FUSION STUDENT ACCOMMODATION

ADDENDUM TO
FLOOD RISK ASSESSMENT AND DRAINAGE STRATEGY
JUNCTION OF DEANS_GATE, CHESTER ROAD
AND BRIDGEWATER VIADUCT, MANCHESTER M3 4LB
FOR FUSION MANCHESTER DEVCO LTD

NOVEMBER 2023
20047.02.03.D101

2.0 LEAD LOCAL FLOOD AUTHORITY COMMENTS

TITLE:
SURFACE WATER DETENTION TANK
AND FLOW CONTROL CHAMBER

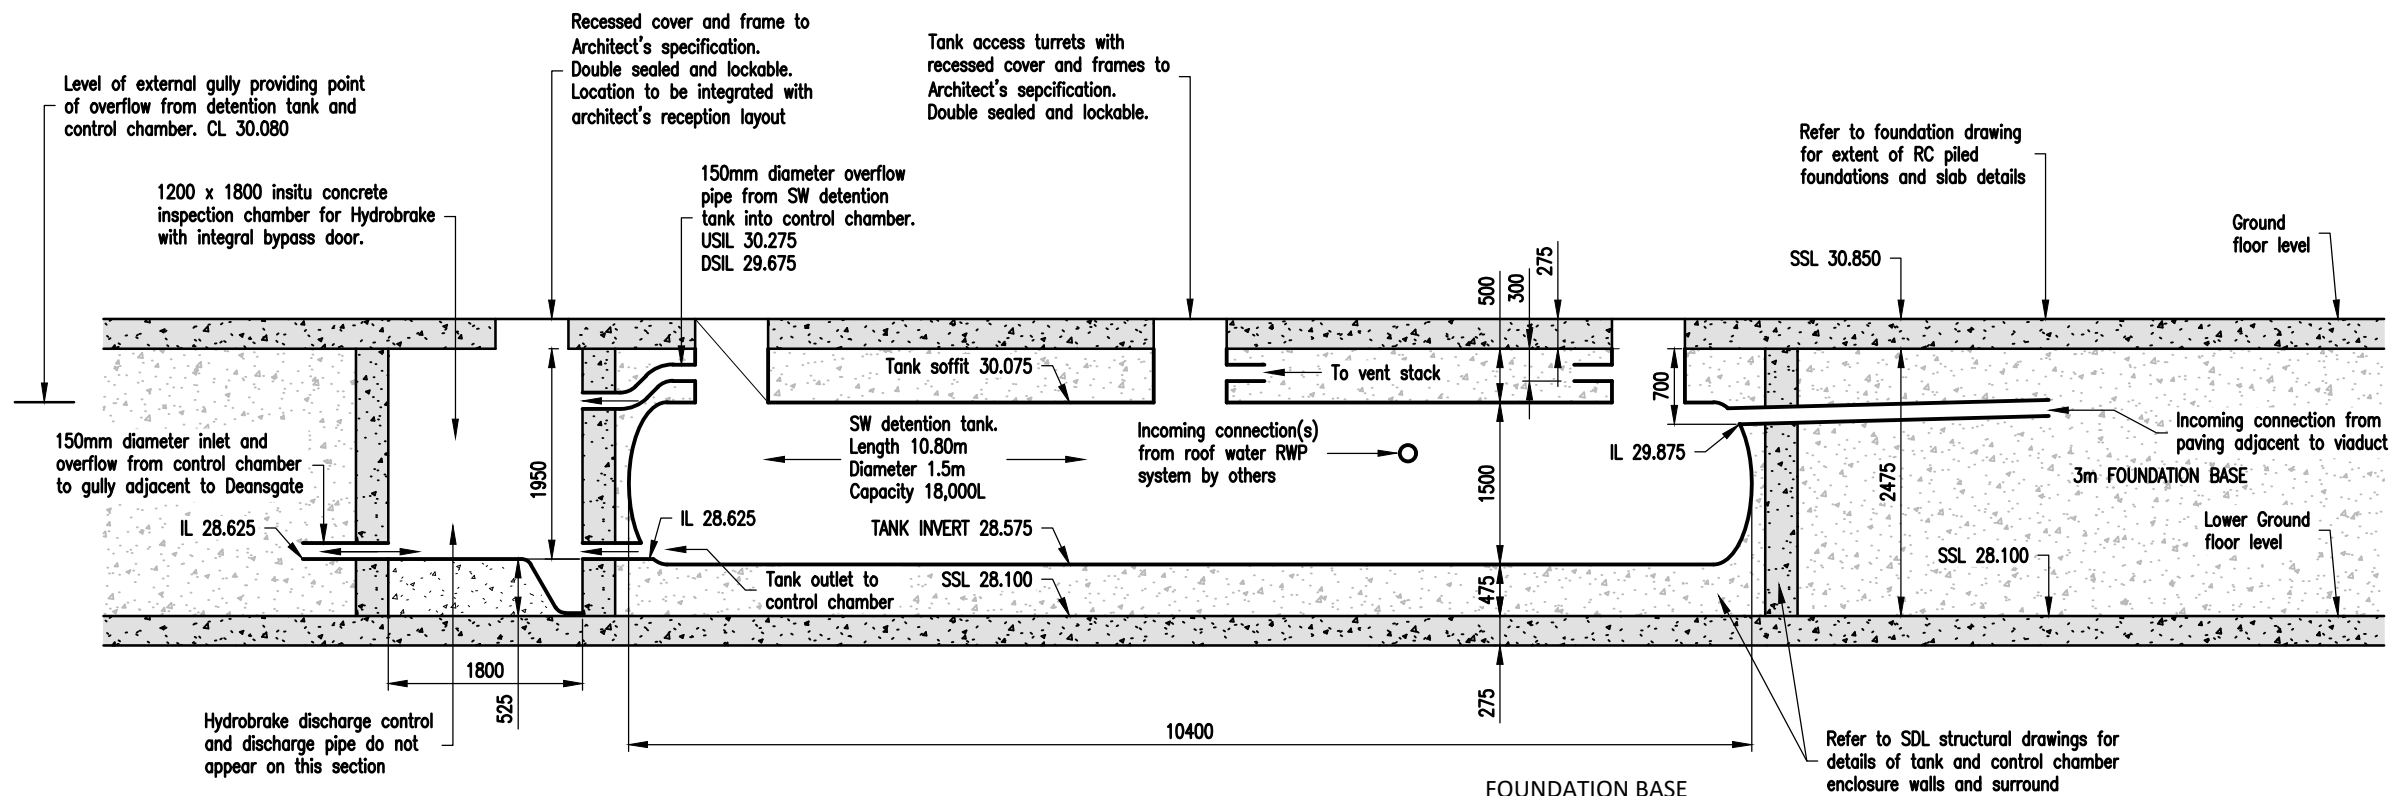
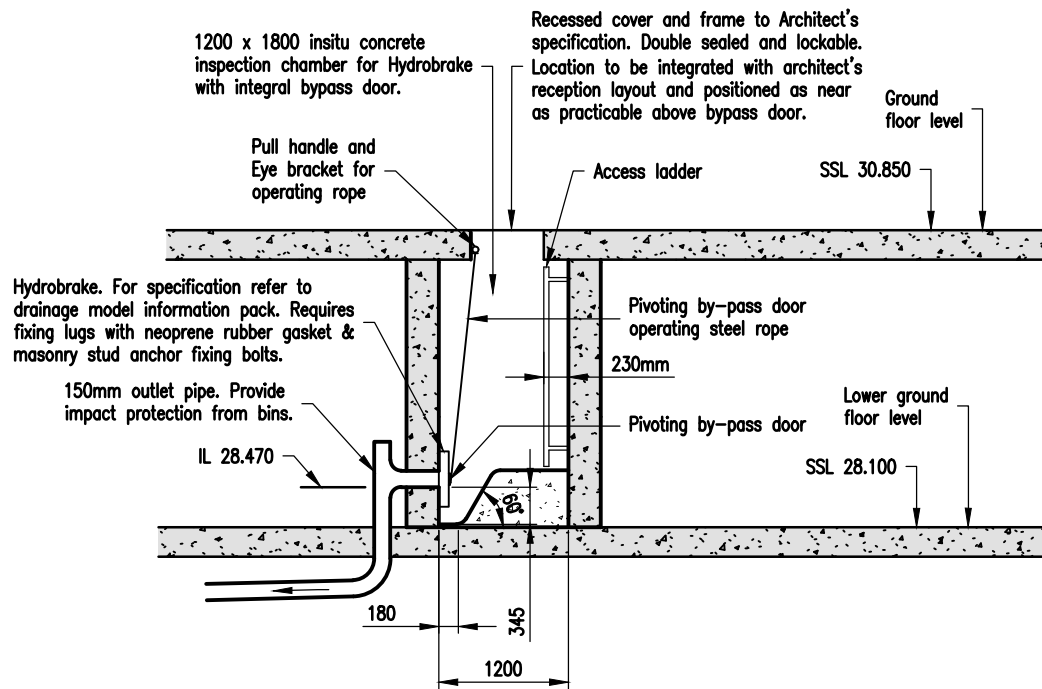
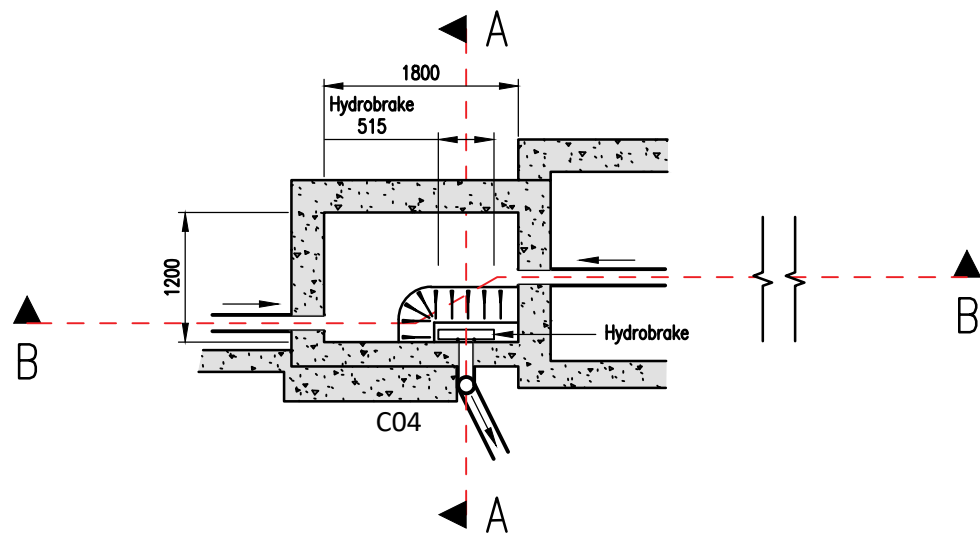
Ground floor drainage layout indicates the tank to potentially 'overflow into the basement tanks during an emergency'. The tank specification must include any overflow levels and detail the specific invert level of proposed overflow.

All attenuation specifications need to be submitted now (emergency overflow tank), to discharge our LLFA interest.

The surface water detention tank and flow control chamber details are shown on drawing 20047-135D in **Appendix D**.

The detention tank has a revised overflow arrangement so that it now overflows via an external gully located on a small paved border adjacent to the footway on Deansgate. Drainage in this paved area, and at the main doorway, connects to the control chamber and flow can travel either way facilitating the overflow. The main doorway is higher than the small paved border and gully so is not at risk of flooding from a situation where the tank is overflowing. Exceedance flows of water from the tank will join other exceedance flow in the manner shown on the drawing within the drainage strategy. Drawing 20047-135D indicates the soffit of the attenuation tank at 30.075 and the overflow gully cover level at 30.080. This ensures that the system will only ever overflow from the gully if the 1 in 100 year storm plus 40% climate change event is exceeded or if there is a blockage in the system downstream of the flow control device.
